Access Compliance Report Public Rights-of-Way (Curb Ramps)

Main Street: THIRD_RD Cross Street: PAVERSTONE Location: SE

ADA ID: RPRK220223143428 Ramp Type: Type 4 - Parallel Initial Pass/Fail: Fail Overall Compliance: No Severity Score: 15

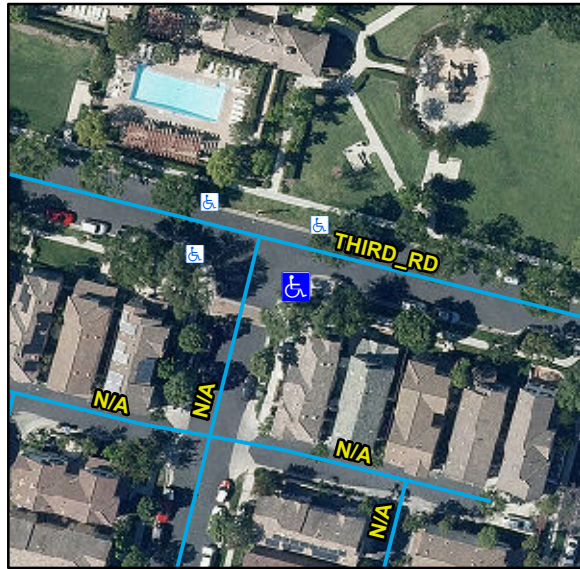
Compliance	Description	Data	Compliance	Description	Data
N/A	Ramp Length LT (in)	120	N/A	Ramp Length RT (in)	114
Yes	Ramp Width LT (in)	91	Yes	Ramp Width RT (in)	91
Yes	Ramp Run Slope LT (%)	5.9	Yes	Ramp Run Slope RT (%)	0.3
No	Ramp Cross Slope LT (%)	6	No	Ramp Cross Slope RT (%)	4
N/A	Landing Present	N/A	N/A	DWS Provided	N/A
N/A	Landing Length (in)	N/A	N/A	DWS Contrast	N/A
N/A	Landing Width (in)	N/A	N/A	DWS Length (in)	N/A
N/A	Landing Run Slope (%)	N/A	N/A	DWS Full Width	N/A
N/A	Landing Cross Slope (%)	N/A		DWS Offset Type	N/A
N/A	Landing Movement Obstructed?	N/A	N/A	DWS Offset Left (in)	N/A
	Landing Movement Type	N/A	N/A	DWS Offset Right (in)	N/A
N/A	Landing Shared	N/A			
N/A	Clear Space	Yes			
N/A	Clear Space To Crosswalk (in)	48			
N/A	Marked Crosswalk 1	No	N/A	Marked Crosswalk 2	No
	Crossing 1 Direction	N		Crossing 2 Direction	W
N/A	Marked Crosswalk 1 Width (in)	N/A		Marked Crosswalk 2 Width (in)	N/A
N/A	Ramp Inside Crosswalk 1	N/A	N/A	Ramp Inside Crosswalk 2	N/A

Remove & Replace Curb Ramp With Two New Directional Ramps or Equivalent.
